## ALERT SERVICE BULLETIN

**412-20-183**

**MODEL AFFECTED:** 412/412EP

**SUBJECT:** FUEL CHECK VALVE P/N 209-062-607-001,  
INSPECTION AND REPLACEMENT OF.

Figure 3. Fuel Check Valve Outside Diameter Measurement

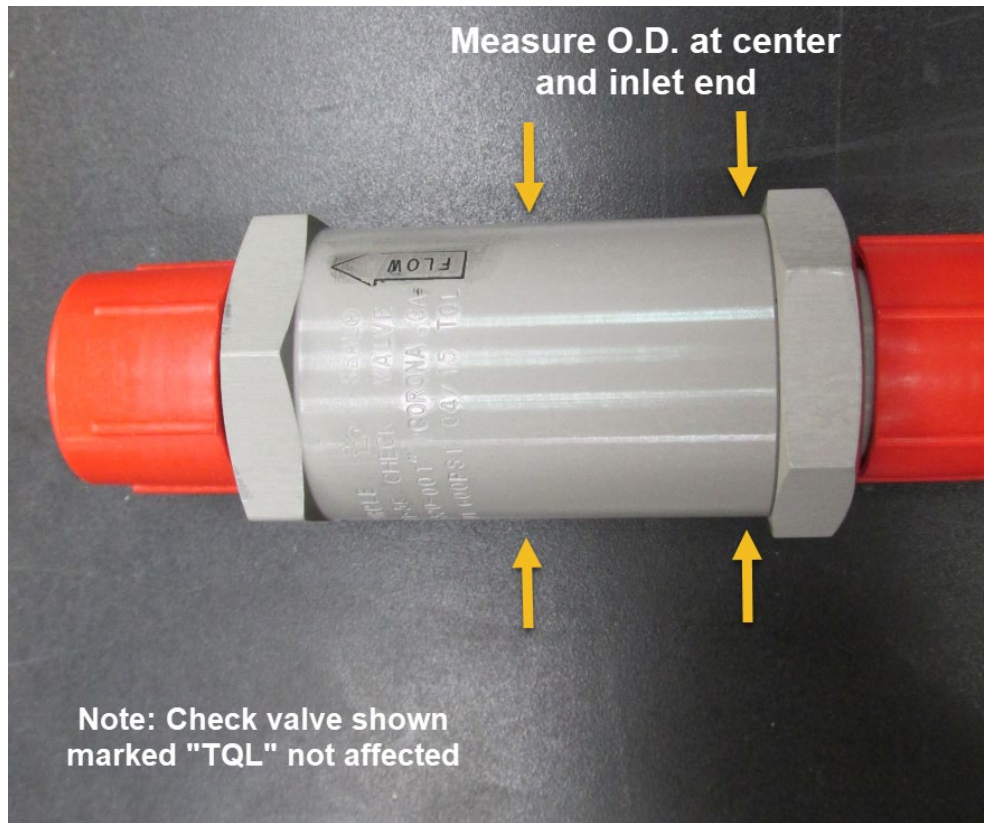
4. If one or both check valves are affected, proceed as follows:
  - a. Using a caliper or equivalent, measure the check valve housing at the center and record dimension (Figure 3).
  - b. Measure the housing at the inlet end where the threaded fitting is installed and record dimension.
  - c. If the dimension measured at the inlet end is no more than 0.003 inch (0.0762 mm) greater than the measurement at the center, the valve is serviceable and does not require further inspection or replacement. Make an entry in the helicopter logbook and historical service records indicating the findings and compliance with this Alert Service Bulletin.

- d. If the dimension measured at the inlet end is greater than 0.003 inch (0.0762 mm) when compared to the measurement at the center, the valve will require replacement. Part III can be accomplished immediately, or Part II can be accomplished until the defective valve can be replaced in accordance with Part III.
- e. If the defective check valve is not replaced immediately, make an entry in the helicopter logbook and historical service records indicating the findings and that Part II must be accomplished every 25 flight hours or 30 days whichever comes first until Part III is accomplished.

Figure 4. Cracked Fuel Check Valve

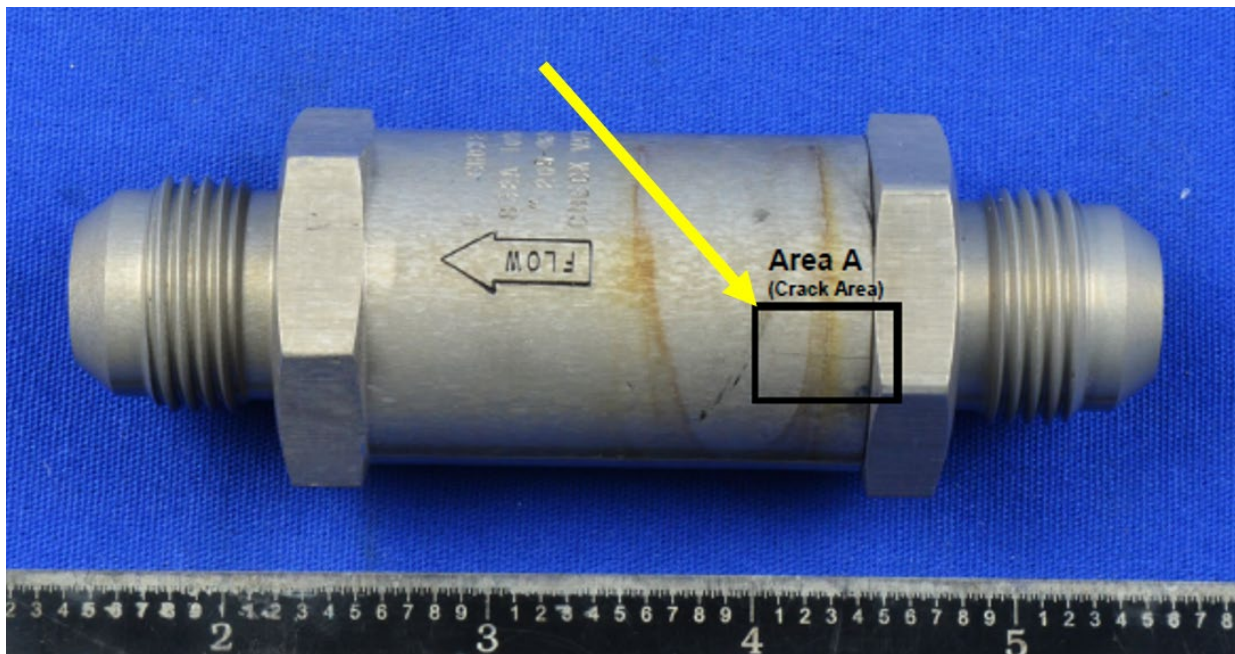
5. Prepare the helicopter for maintenance and gain access to the fuel check valves (Figure 1).
6. Using a strong light source, visually inspect the fuel check valves for general condition and fuel leaks. Inspect for cracks at the inlet end where the threaded fitting is installed (Figure 3).
7. If a crack is found, replace the check valve prior to next flight. Figure 4 shows an example of a cracked check valve.
8. If no cracks or any other defects that would cause the valve to be unserviceable are found, make an entry in the helicopter logbook and historical service records
